NORTHERN STATES POWER COMPANY
MONTICELLO NUCLEAR GENERATING PLANT

REQUEST FOR AMENDMENT TO OPERATING LICENSE NO. DPR- 22 -----

(License Amendment Request Dated December 1, 1975)

PROPOSED CHANGES TO TECHNICAL SPECIFICATIONS
APPENDIX A OF PROVISIONAL OPERATING
LICENSE NO. DPR-22

Figure 1. Turbine Trip Without Bypass

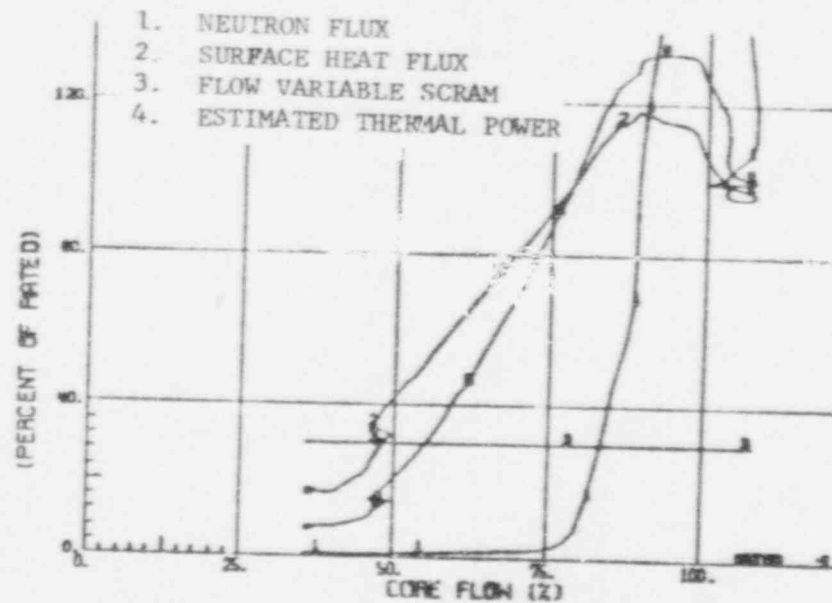
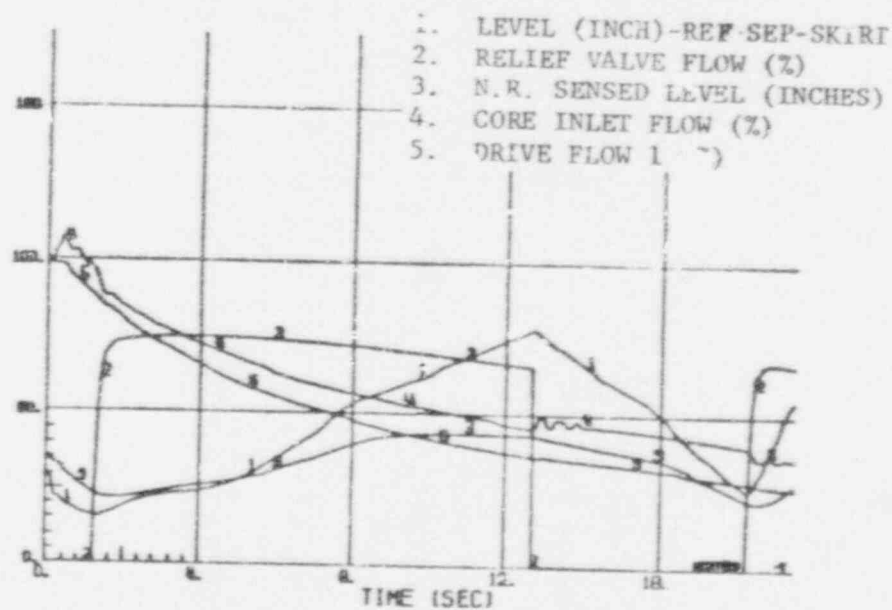
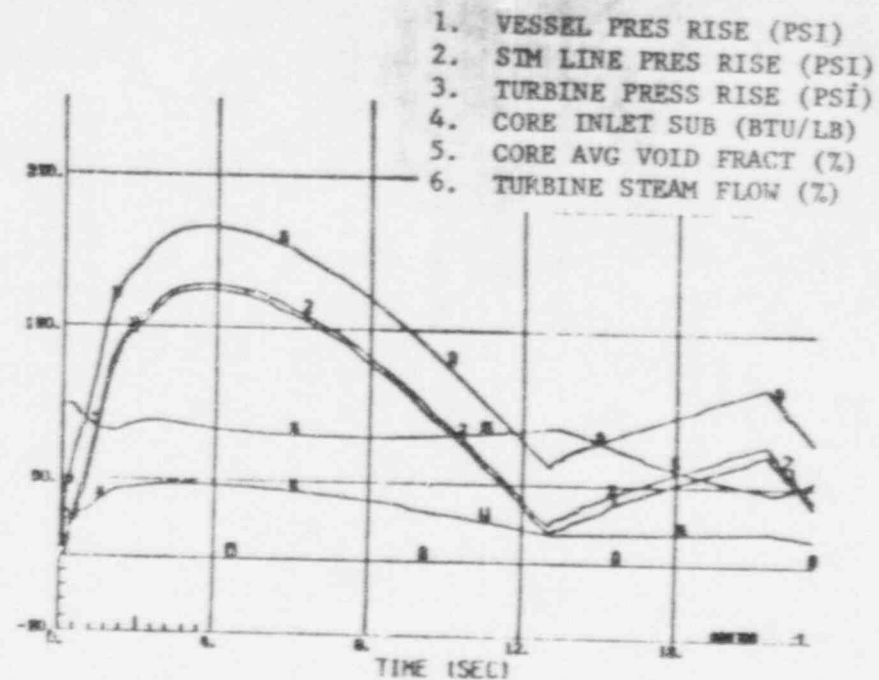
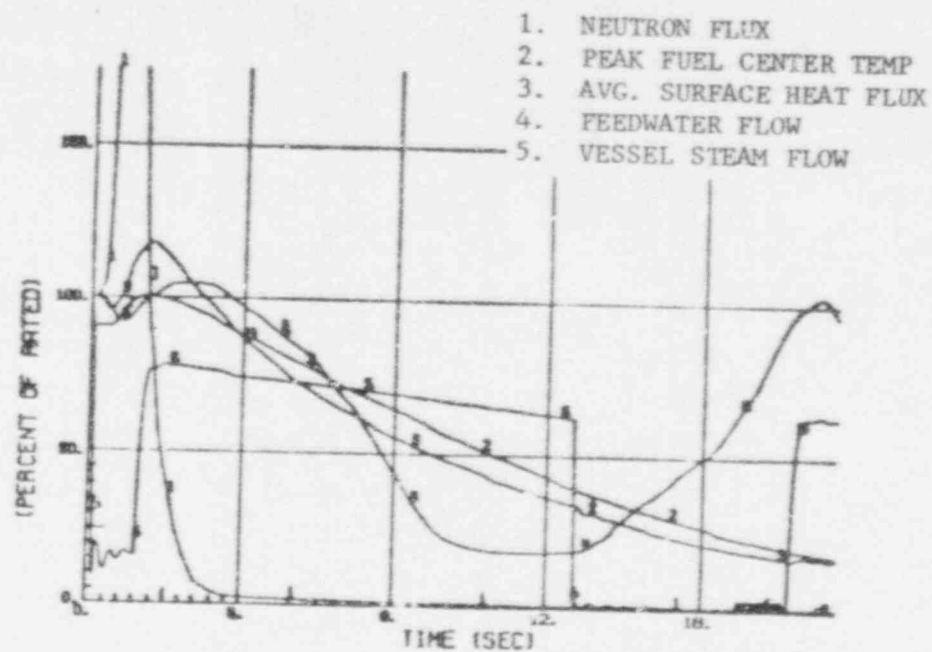
The operating MCPR limit is derived by adding to the MCPK safety limit the maximum delta CPR of the abnormal operational transients analyzed. For Cycle 5 it has been determined that the turbine trip with failure of the bypass valves to open is the most limiting abnormal operating transient. The delta CPR values were calculated to be 0.23 and 0.32 for 7 x 7 and 8 x 8 fuel respectively; the Technical Specification MCPR safety limit remains 1.06, resulting in operating MCPR limits of 1.29 and 1.38 for 7 x 7 and 8 x 8 fuel respectively. The reactor transients and the thermal hydraulic responses were analyzed as described in the topical report, "GE/BWR Generic Reload Licensing Application for 8 x 8 Fuel, Revision 1, Supplement 2, May 1975, NEDO-20360." The input and output parameters are presented in Tables 1, 2 and 3 and in Figure 1.

On page 189D, TS 3.11.C and on page 189F, first paragraph of Bases 3.11.C, change the operating MCPR limits from "1.41" to "1.38" and from "1.33" to "1.29" for 8 x 8 and 7 x 7 fuel respectively.
